THE PURPOSE OF THIS PLAN IS TO REVISE THE SEPTIC AREA ON LOT 9 FOR THE PURPOSE OF A POOL ADDITION.

PERC RECERTIFICATION PLAN
SCHOOLEY MILL FARM
LOT 9

PARCEL: 115
HOWARD COUNTY, MARYLAND
DATE: MARCH 7, 2017

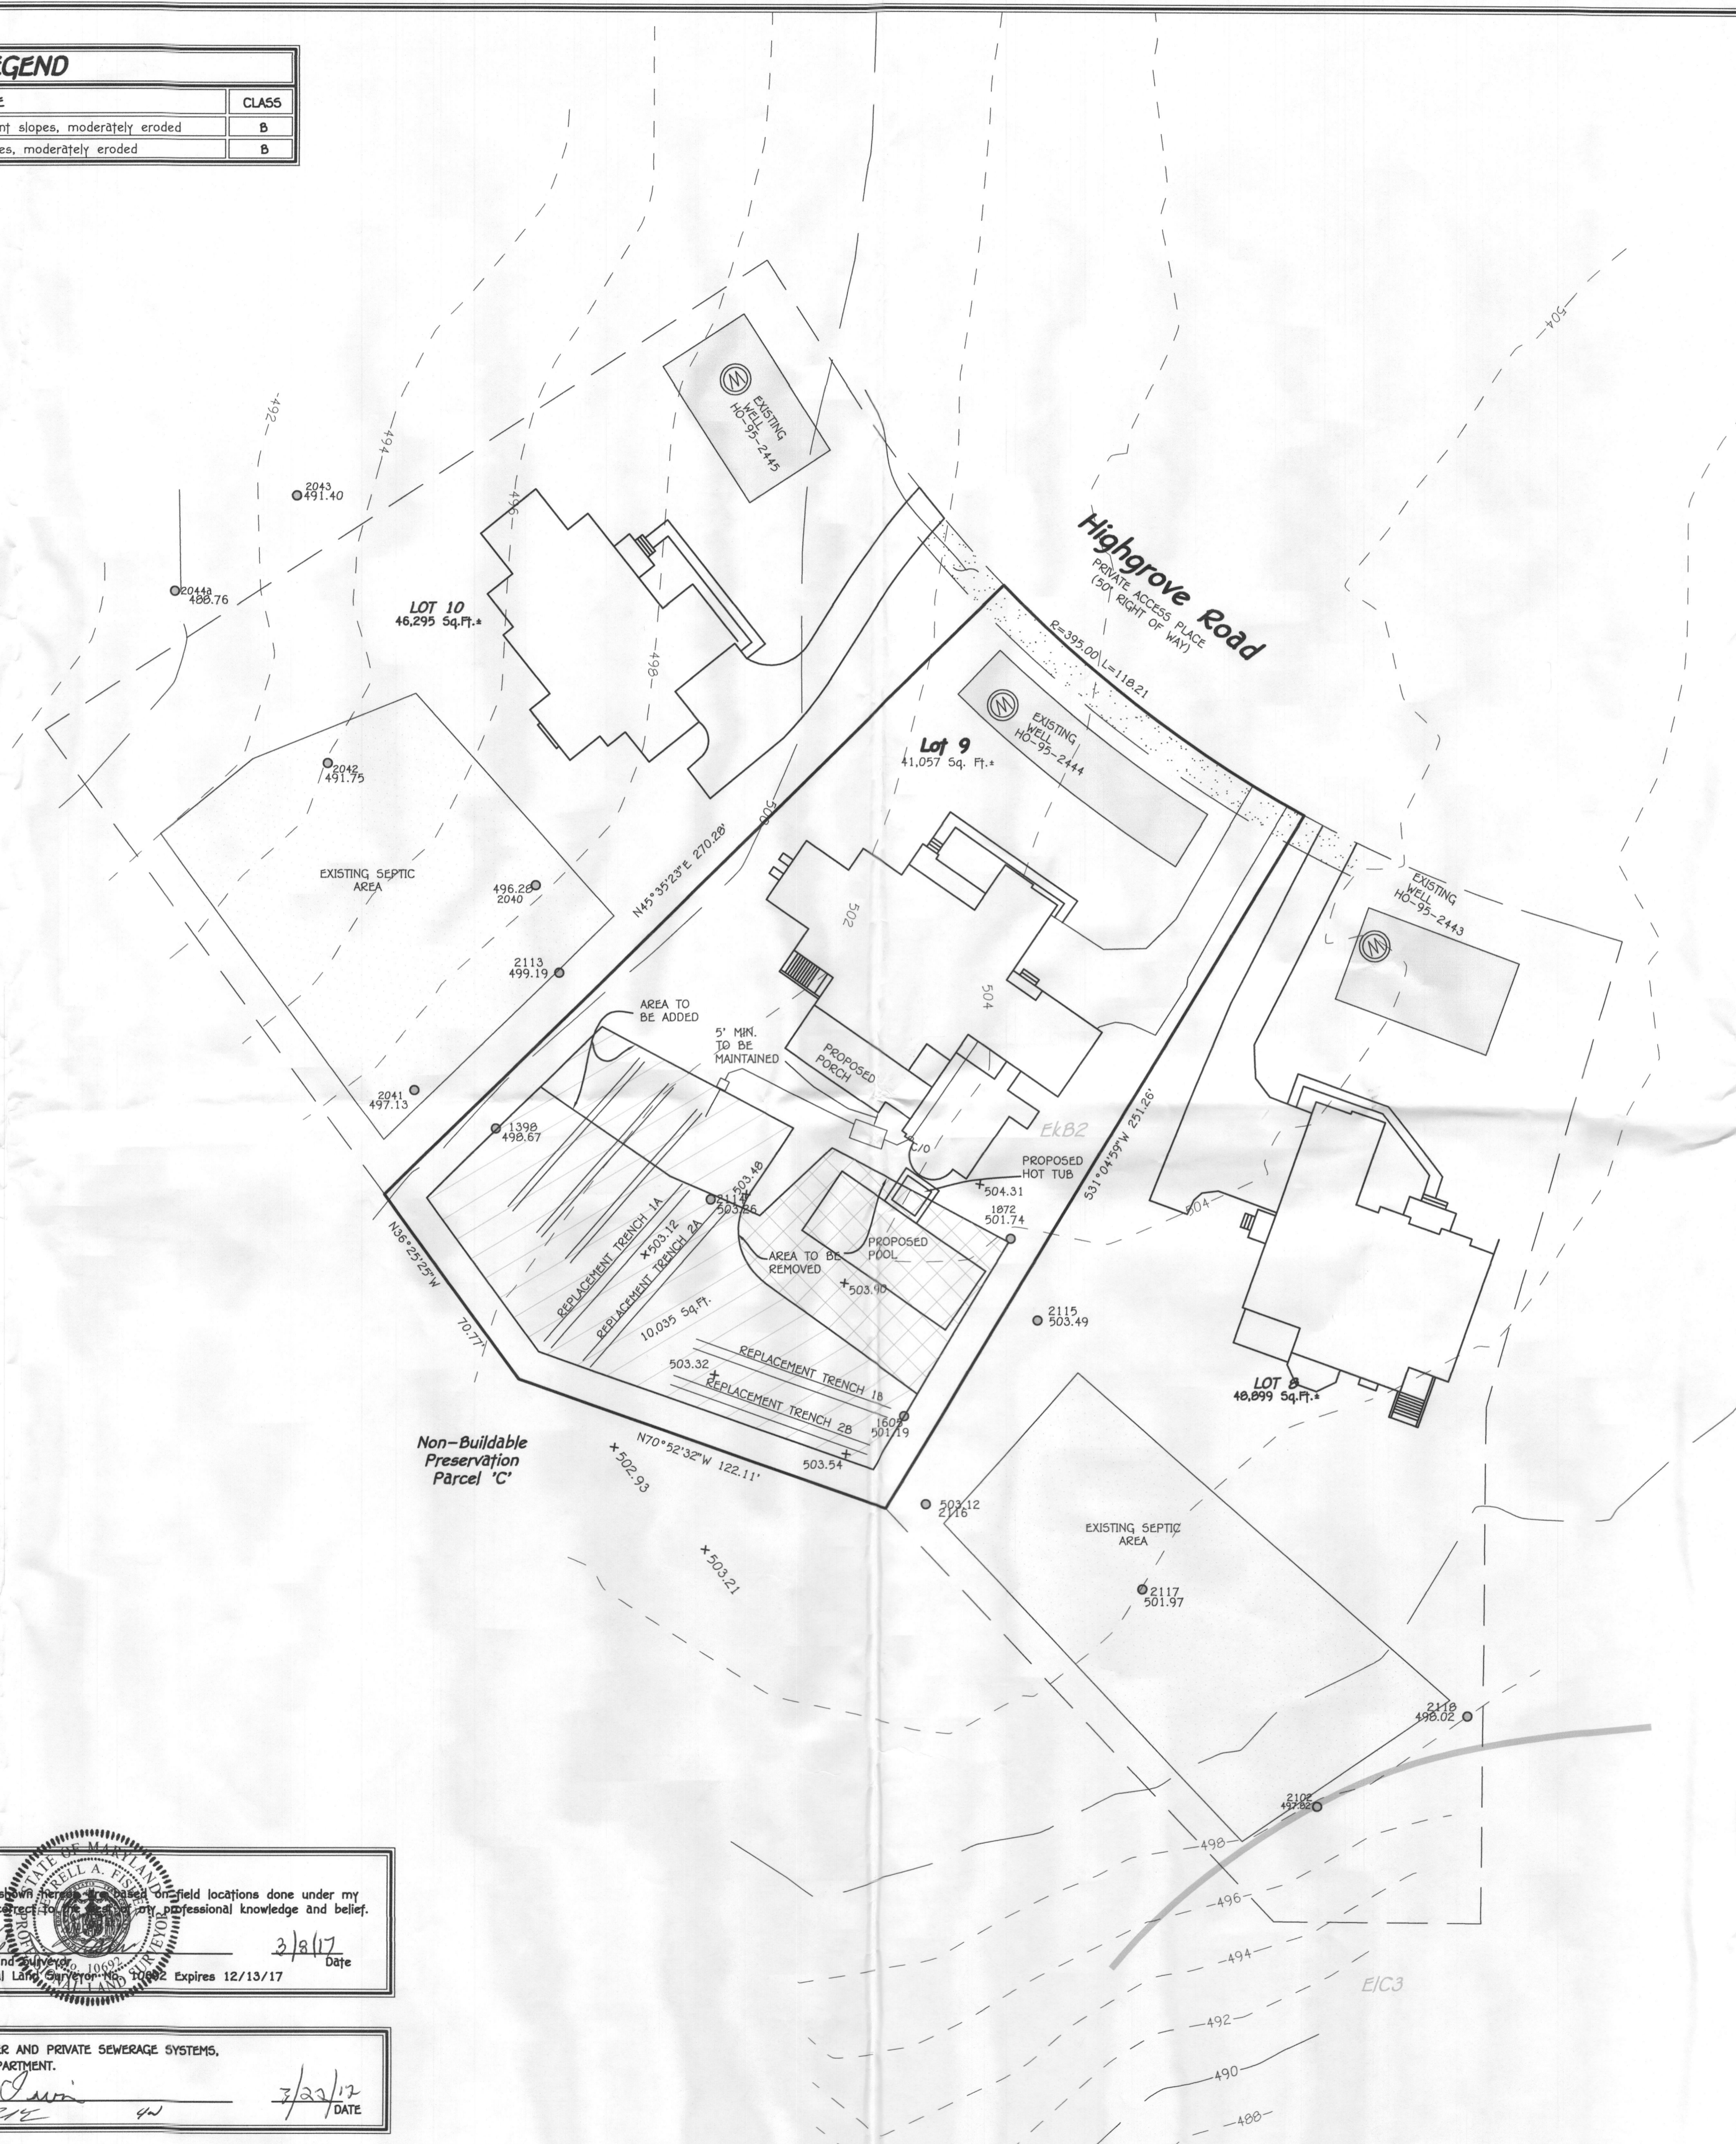
- ADJUSTMENTS TO SEPTIC EASEMENT AREA IS NOT PERMITTED WITHOUT ADDITIONAL TESTING AND A REVISION RECERTIFICATION PLAN. *NOT per Tony Fertitta*
- THE LOT SHOWN HEREON COMPLIES WITH THE MINIMUM OWNERSHIP WIDTH AND LOT AREA AS REQUIRED BY THE MARYLAND STATE DEPARTMENT OF THE ENVIRONMENT.
